**SAN JOSE DOWNTOWN
ASSOCIATION**

September 29, 2010

Neighborhood and business groups in central San Jose urge the California High Speed Rail Authority (CHSRA) to include an underground option for San Jose in the project's Environment Impact Report.

Reasons to Keep HSR Tunnel Option in the Mix

Figure 1,

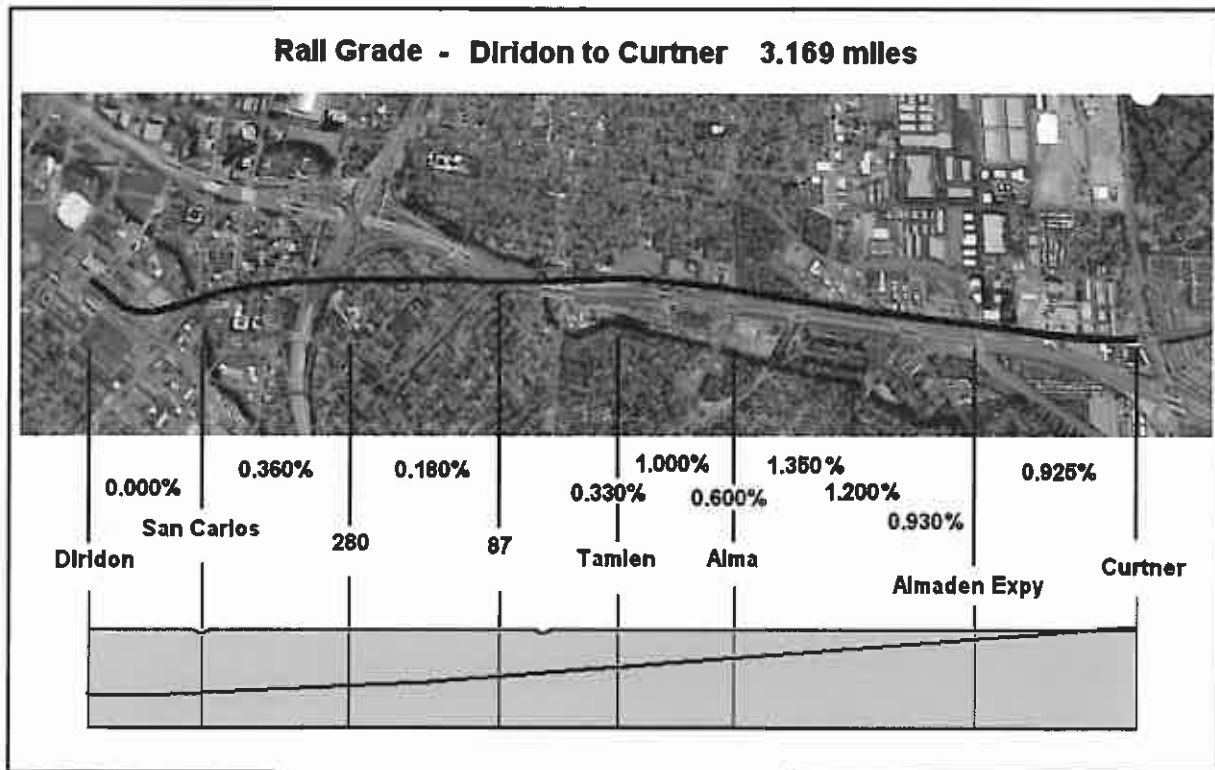
The 5100m alignment gets its name from the tunnel which begins just north of Curtner Avenue, crossing at right angles under the Guadalupe River north of Willow Street, and unobtrusively beneath highly valued TOD and RDA land to Diridon Station. It will:

Note: Final 5100m track grade and depth at Diridon designed as appropriate for final station design.
